Access Compliance Report

Public Rights-of-Way

(Curb Ramps)

Intersection ID: 52172	Main Street: BEARLING_WY	Cross Street: AVERY_MEADOWS_DR	Location: SW
ADA ID: 741A2DDE40E4	Ramp Type: Perp	Initial Pass/Fail: Fail	Overall Compliance: No
Severity Score: 1.25			
Codes/Mitigation Info/Possible Solution		Field Measurements/Component Compliance

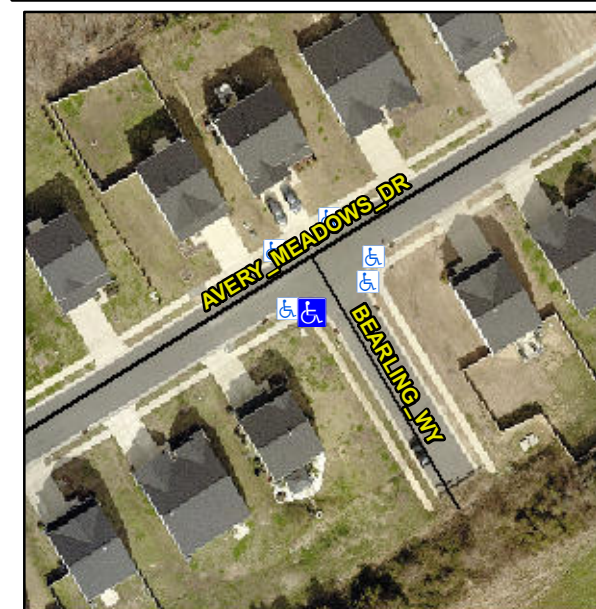
Not Found, R304.5.3

Compliance	Description	Data	Compliance	Description	Data
N/A	Ramp Length (in)	48.0	Yes	Ramp Slope (%)	8.0
Yes	Ramp Width (in)	48.0	No	Ramp XSlope (%)	2.1
N/A	Flare Type LT	N/A	N/A	Flare Type RT	N/A
N/A	Flare Slope LT (%)	N/A	N/A	Flare Slope RT (%)	N/A
N/A	Flare Traversable LT?	N/A	N/A	Flare Traversable RT?	N/A
N/A	Landing Length (in)	N/A	N/A	DWS Provided?	N/A
N/A	Landing Width (in)	N/A	N/A	DWS Contrast?	N/A
N/A	Landing Slope (%)	N/A	N/A	DWS Length (in)	N/A
N/A	Landing X Slope (%)	N/A	N/A	DWS Full Width?	N/A
N/A	Landing Curb? (Y/N)	N/A	N/A	DWS Offset (in)	N/A
N/A	Shared Landing?	N/A			
N/A	Gutter Ponding?	N/A	N/A	Gutter Slope (%)	N/A
N/A	Gutter Lip Ht (in)	N/A	N/A	Gutter X Slope (%)	N/A
N/A	Painted X Walk1?	No	N/A	Painted X Walk2?	N/A
	X Walk 1 Direction	To E		X Walk 2 Direction	N/A
N/A	X Walk 1 Width (in)	N/A	N/A	X Walk 2 Width (in)	N/A
	X Walk 1 Slope (%)	3.7		X Walk 2 Slope (%)	N/A
	X Walk 1 X Slope (%)	0.5		X Walk 2 X Slope (%)	N/A

Remove & Replace Entire Ramp.
